HIDEOUT, UTAH PLANNING COMMISSION PUBLIC HEARING AND REGULAR MEETING

March 18, 2021

Staff Review of Subdivision Plans Submittal

Re: Deer Waters – Phases 3 & 4 Plan Review

Town Map - Location of Proposed Subdivision

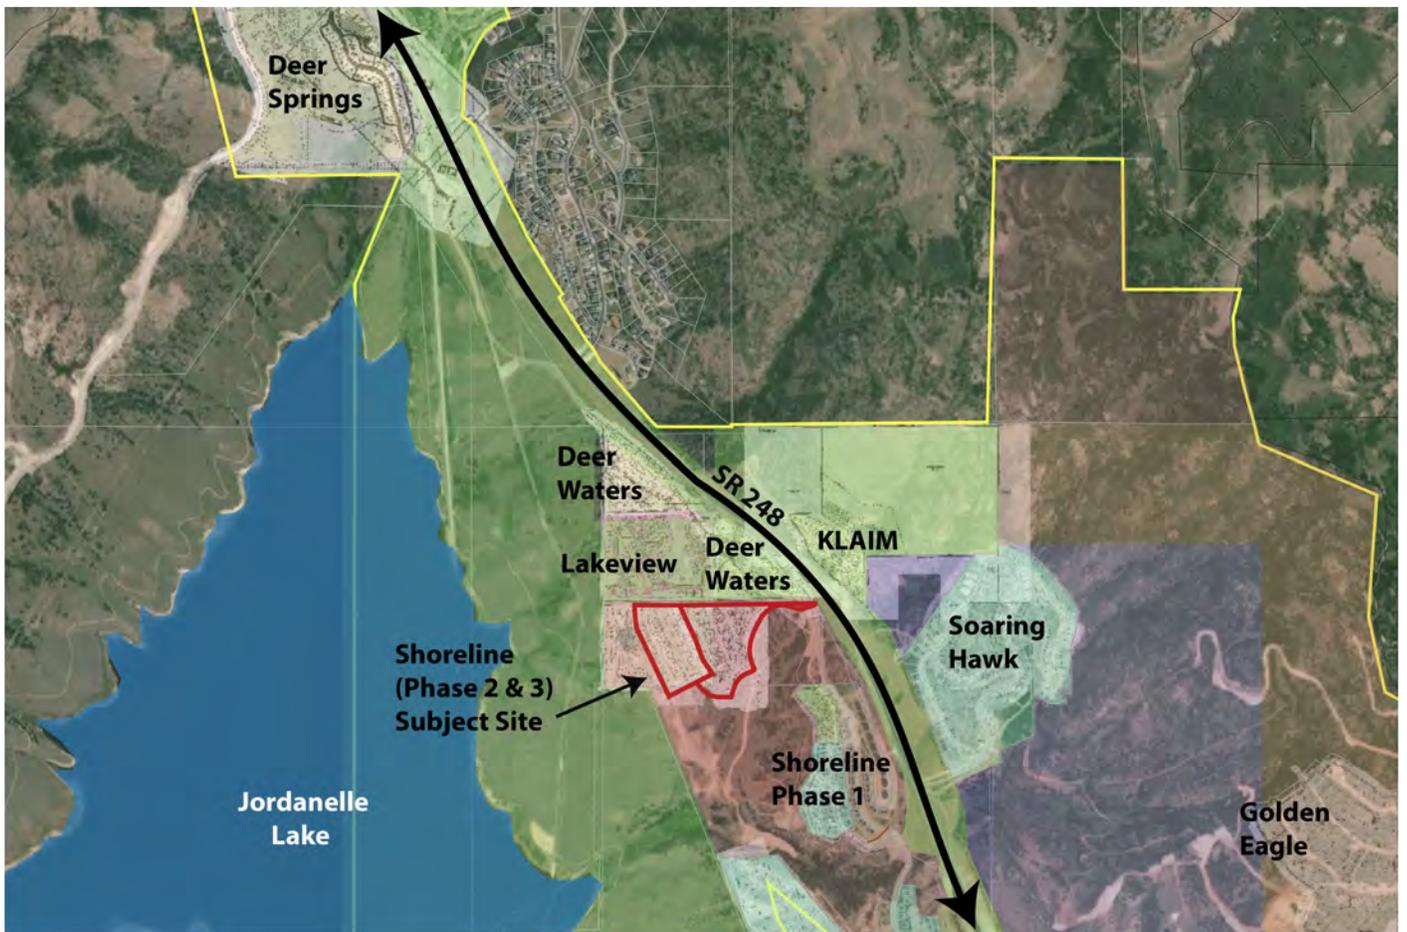
An initial review of the proposed Phase 2 (Amended) and Phase 3 Subdivision indicates the following issues must be addressed:

3. The width of the proposed roads (pavement/cart way) as well as right-of-way area should be clearly noted on the supporting plans.
 - a. For Phase 3, the roads appear to be 18'-0" of asphalt and 5'-0" of curb and gutter for a total of 23'-0" in width. The Applicant must confirm that is correct for all roadways proposed. The Applicant must further confirm that curbs and gutters be provided for all proposed roads.

- b. No right-of-way width is illustrated.
 - c. Where is visitor parking proposed to be located? None is illustrated on the plans. Possible 'bump out' areas with signage? Additional visitor spaces such as those incorporated into Shoreline Phase 1? How many are proposed?

Phase 2 (Amended) – Specific Planning Issues

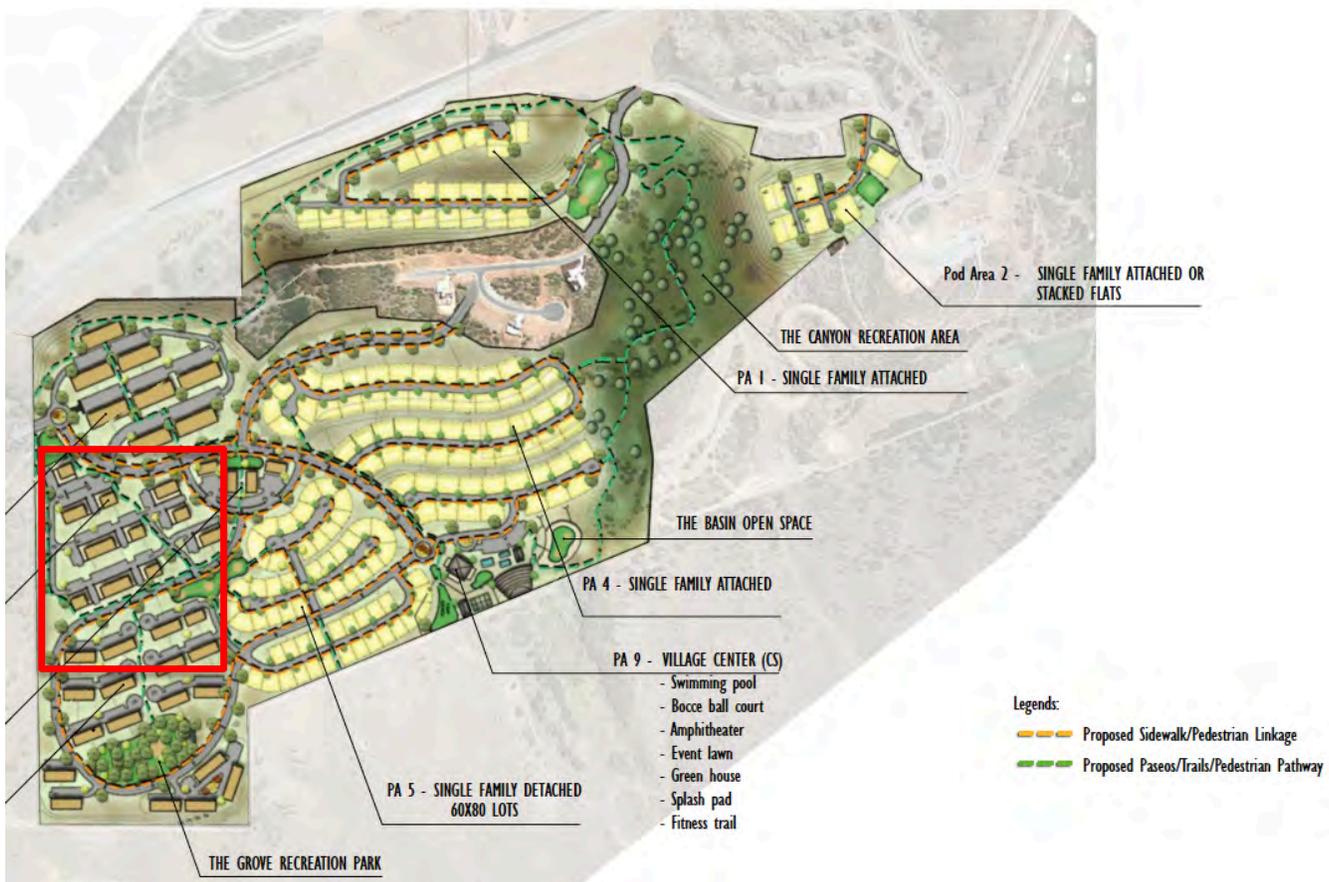
1. Note #1 in the 'Notes' on the Phase 2 Amended Subdivision states that '*all common area is to be considered a drainage and public utility easement.*'

- a. The Applicant has not illustrated the existing Public Utility Easement(s) on the proposed subdivision plan. This should be shown on the proposed subdivision.

- b. This note should be revised to identify the areas that are common areas for HOA use vs. those areas that will be designed for green drainage infrastructure and those that will be used as parks and open space.

2. The original submission for Phase 2 approval included a Landscape Plan with an Aspen Grove that was to be preserved and incorporated into a park and integrated trail system. Per a site visit in January, all of the trees included within this area to be preserved have been removed. The Applicant shall explain this deviation from the previously approved Phase 2 subdivision plans and how this oversight will be resolved.
